Service Letter No. 446 October, 1995

SUBJECT: Solenoid Replacement Group (12 VDC) Screw

MODELS AFFECTED: 750/760/760A/765

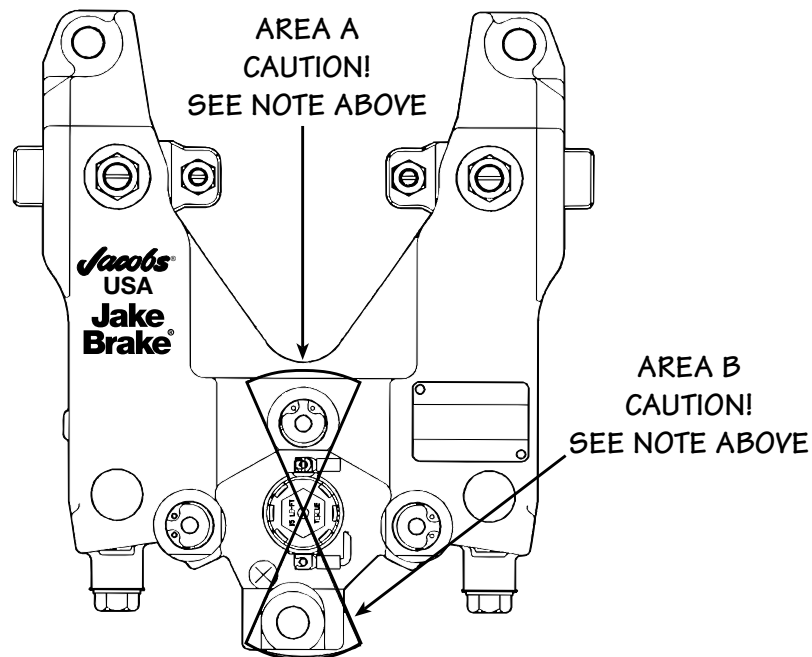
The current solenoid valve (P/N 016440) used in these model engine brakes has a 0.25" spade-style connector. Over time and use, these connectors can loosen, allowing the harness to separate from the solenoid terminal. The condition will render the engine brake housing inactive, reducing the overall retarding power available.

Use of this new solenoid group will prevent this condition from occurring by providing a screw-type connection at the solenoid valve and a harness adapter to allow for the use of the engine wiring harness without modification. This screw-type connection provides a positive attachment at the solenoid valve.

Part Number	Description
021484	Solenoid Replacement Group (12 VDC) Screw
01-020237	• Solenoid (12 VDC) S/L screw (including seal rings)
021413	• Harness adapter blade/screw
021483	• Instruction sheet
